INSTRUCTIONAL BULLETIN NO. 17-12

Regarding Revised Natural Stream Design Standard Drawings

Effective March 23, 2018 letting (January 10, 2018 Turn-in), the following standard drawings have been revised. Also, Chapter 5 of the Roadway Design Guidelines has been revised to incorporate these changes.

STANDARD LEGEND

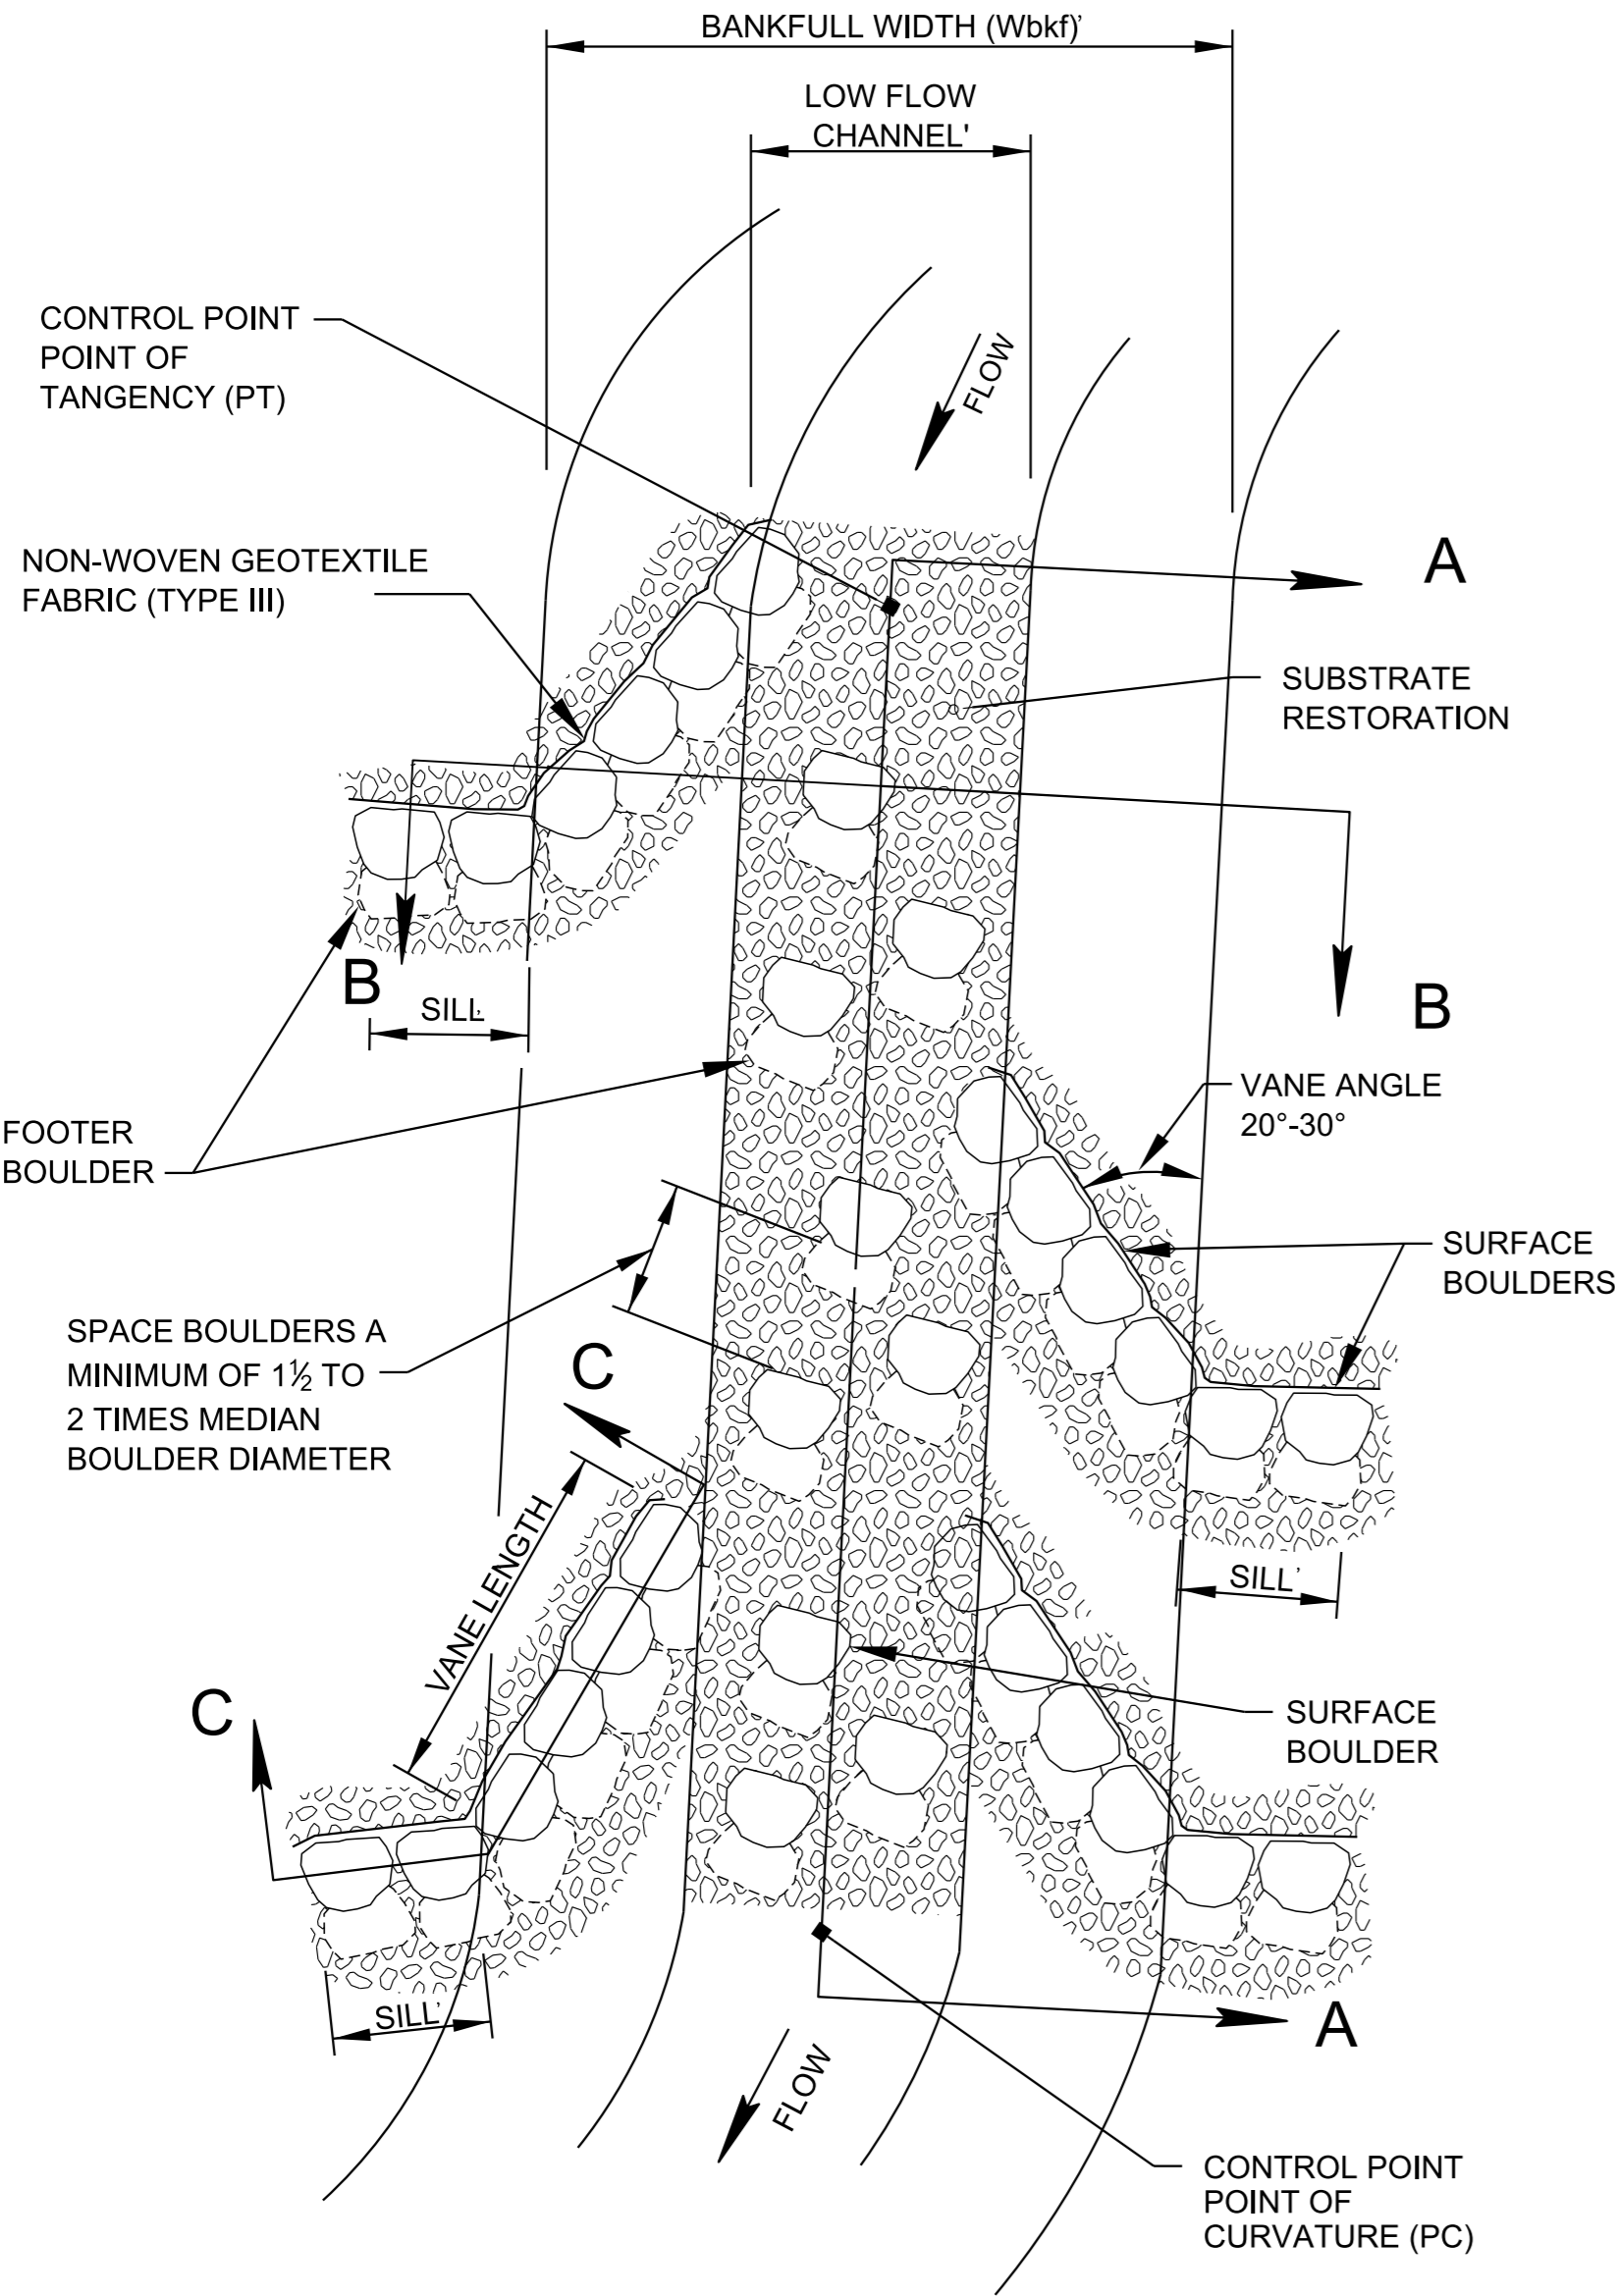
REV. 9-15-17: DELETED VARIOUS ITEMS. MODIFIED VARIOUS ITEMS. ADDED STD. DWG. NAMES. REDESIGNED VARIOUS ITEMS. ADDED LEGENDS FOR BOULDER TOE AND COIR FIBER EROSION CONTROL BLANKETS.

WOOD TOE
PLAN VIEW

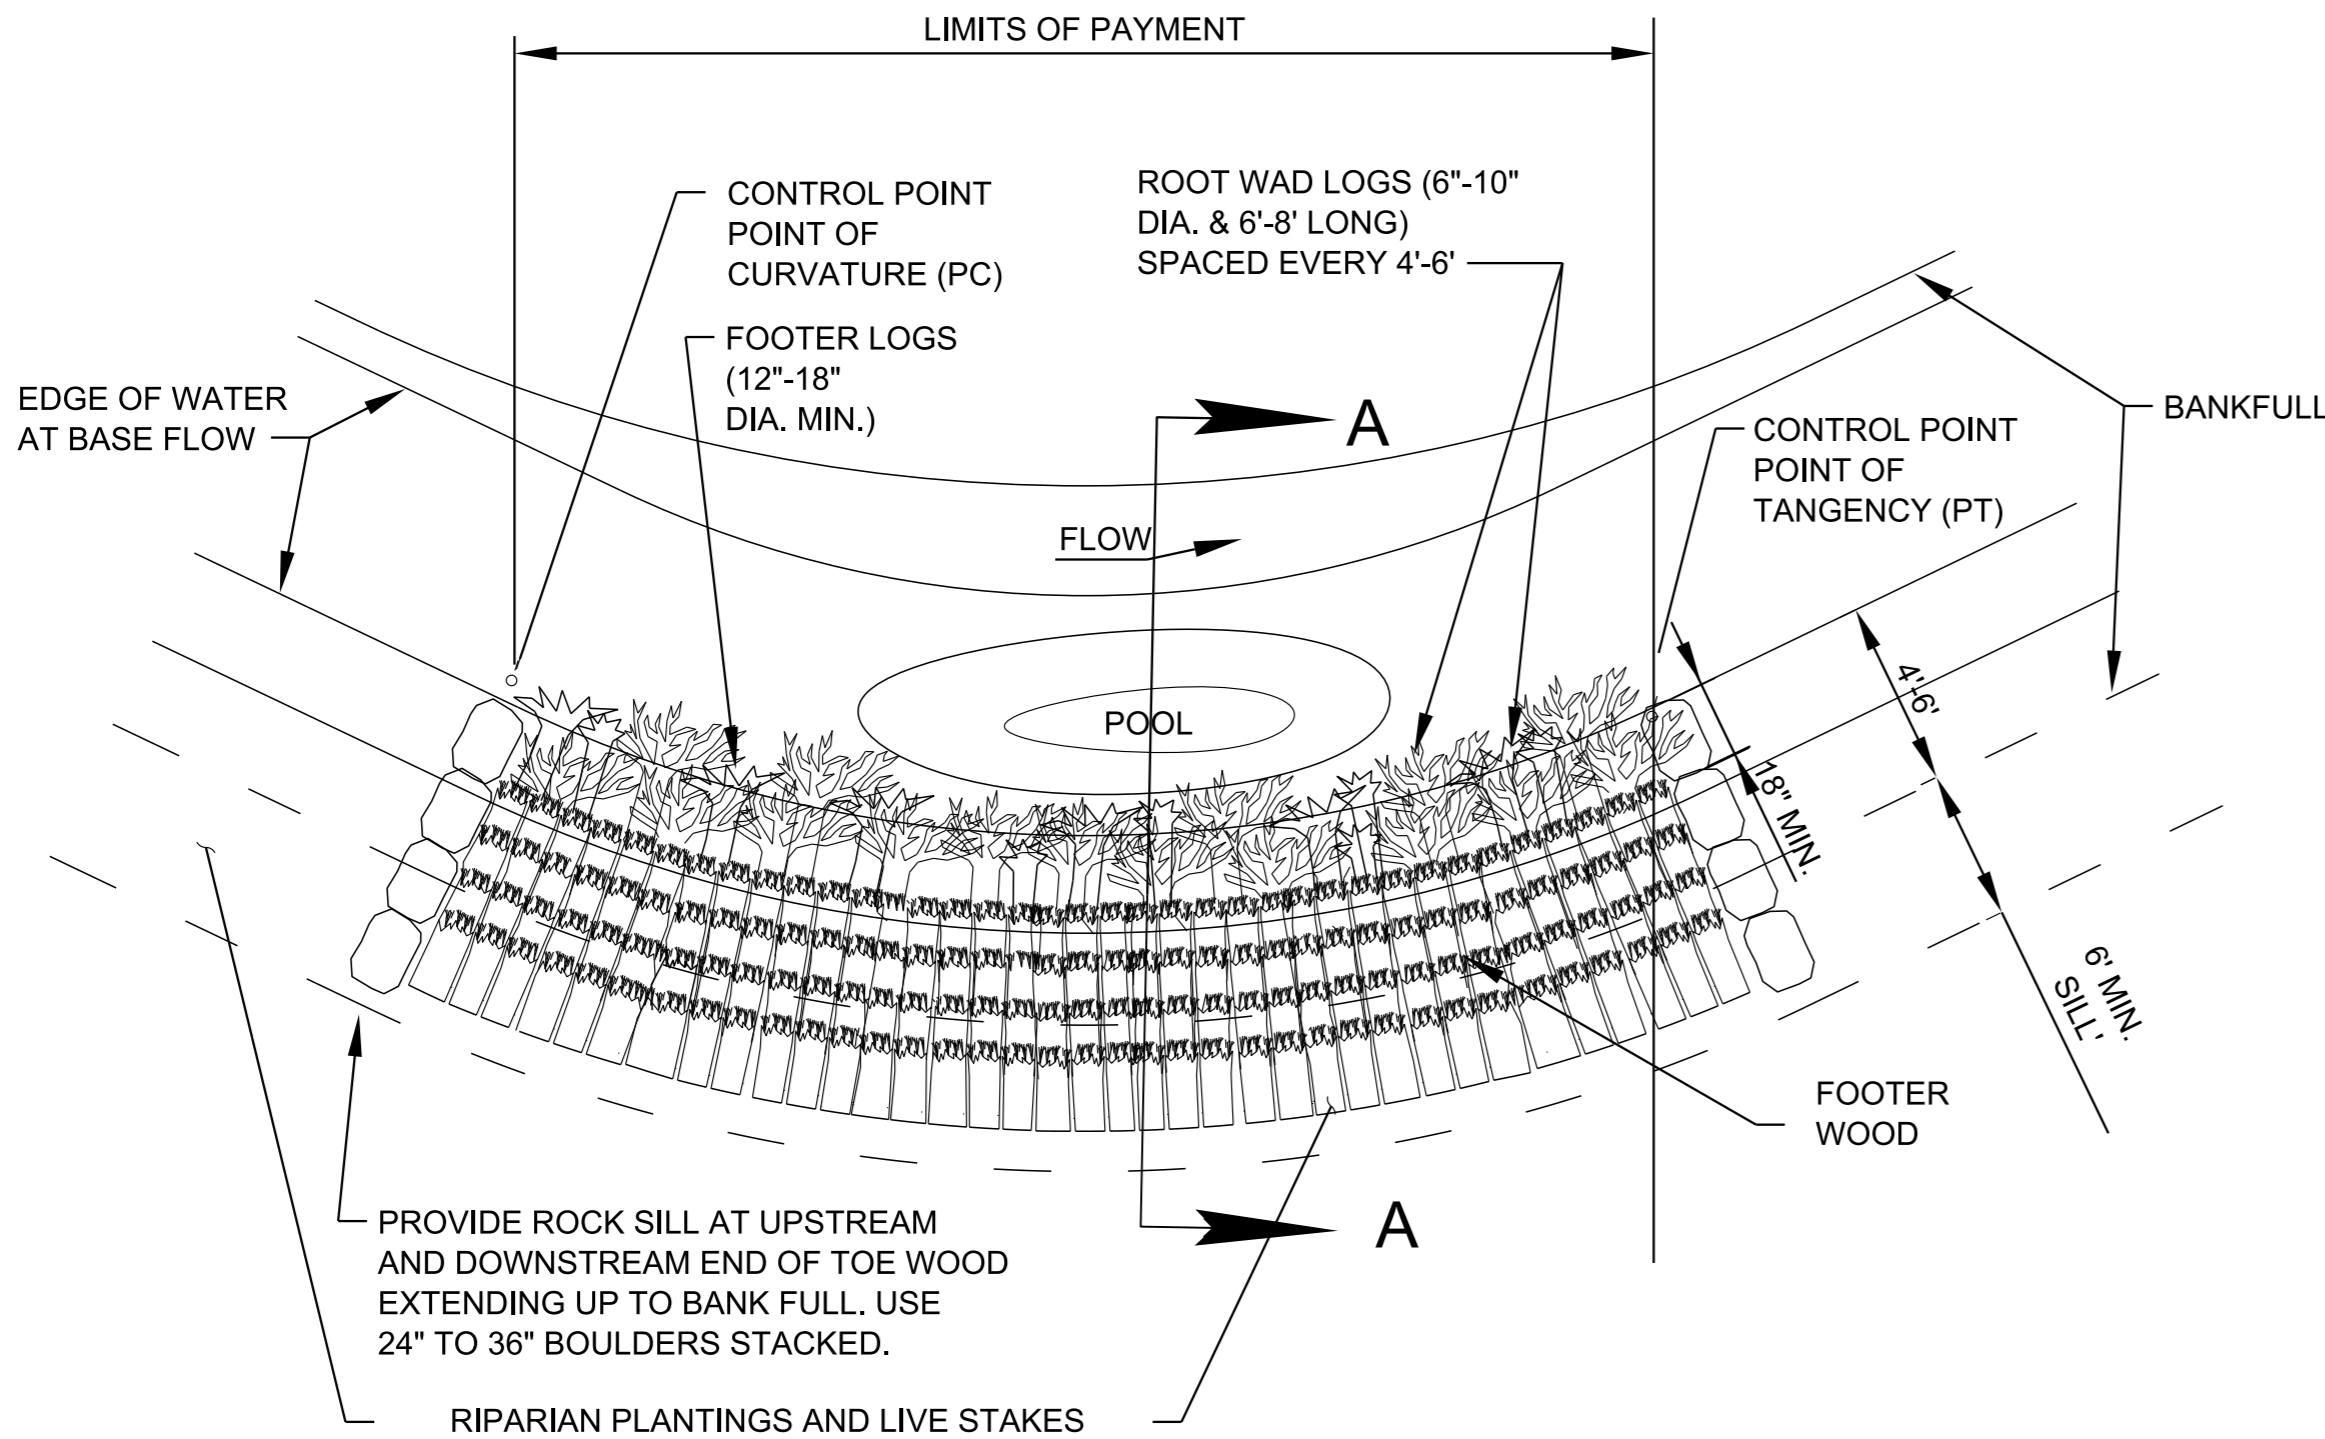
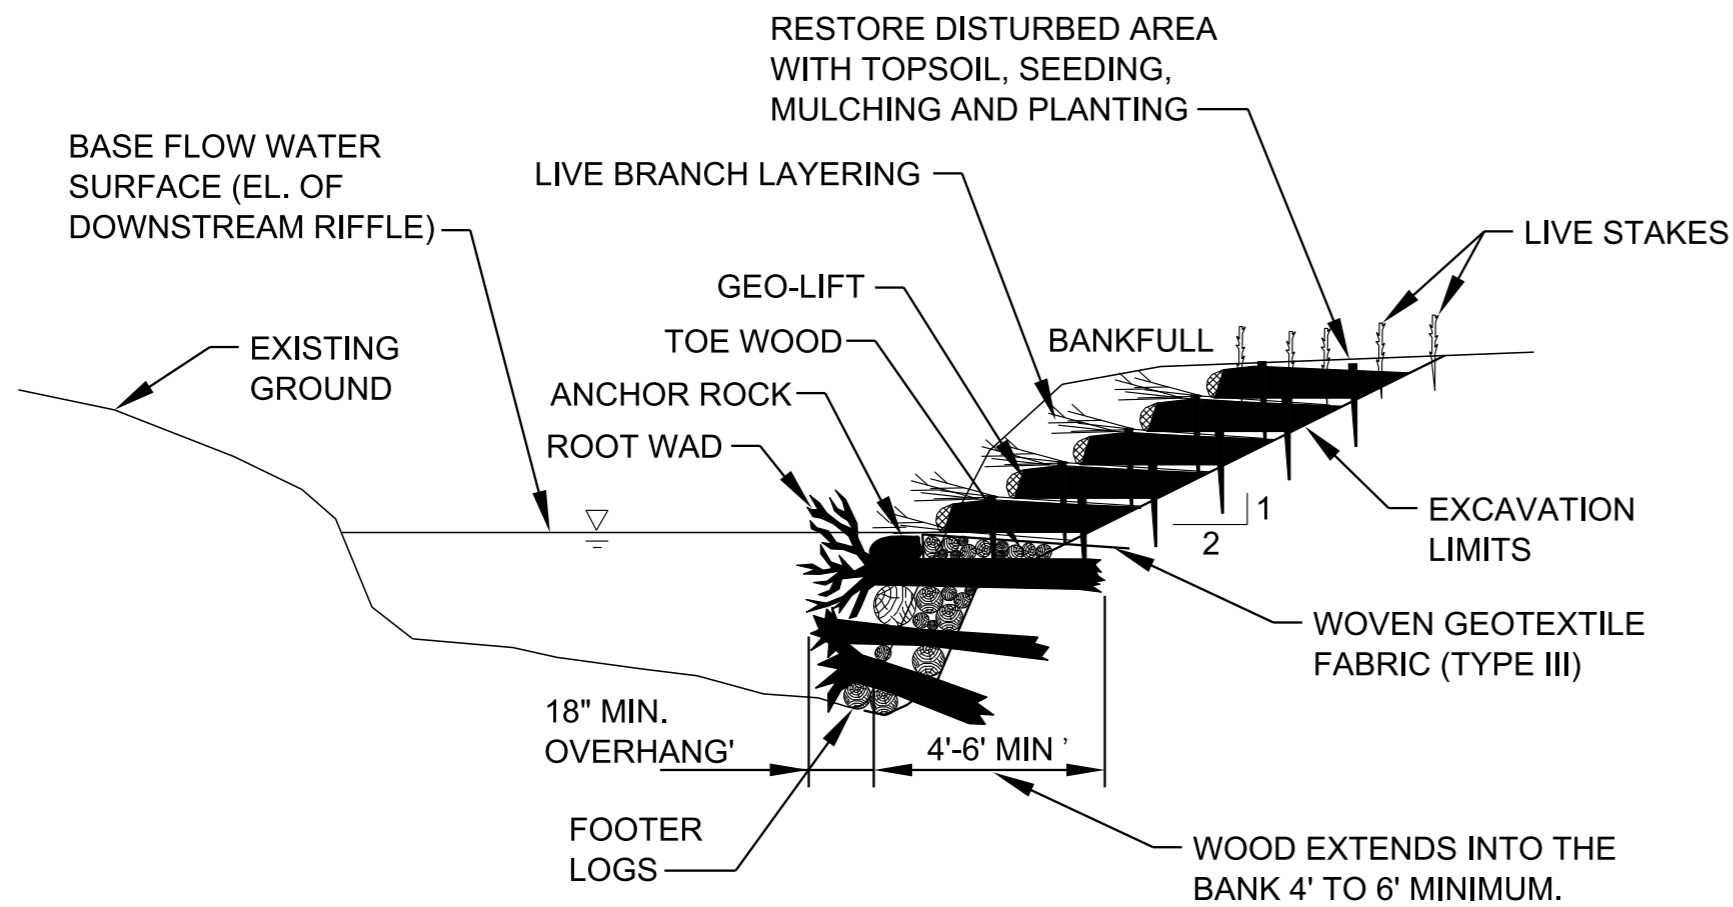
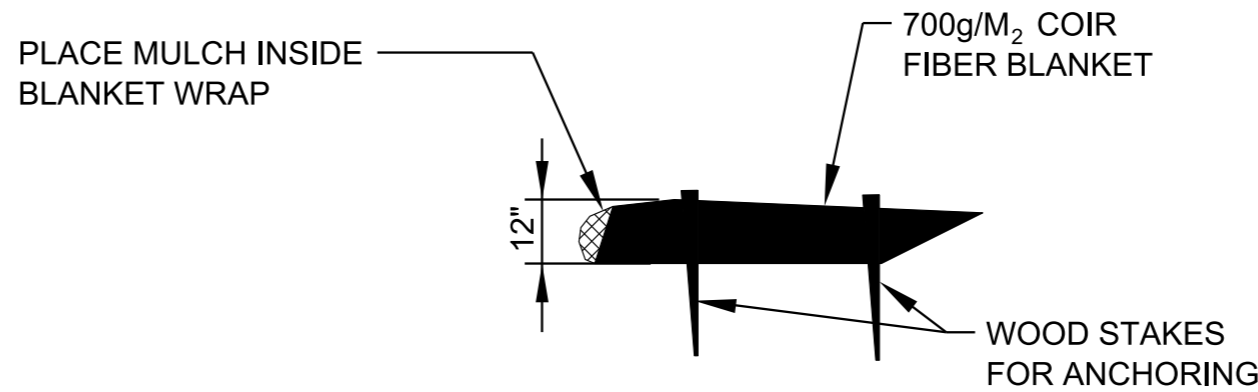
REV. 9-15-17: MODIFIED PAY ITEM DESCRIPTION. MODIFIED THE STREAM MITIGATION PLAN LEGEND SYMBOL. ADDED NOTE (H). MODIFIED WOOD TOE PLAN VIEW. ADDED "GEO-LIFTS" AND "AS DIRECTED BY THE ENGINEER" TO THE REINFORCED EARTH DETAIL. MODIFIED DRAWING NAME. MODIFIED PLAN VIEW AND LEGEND.
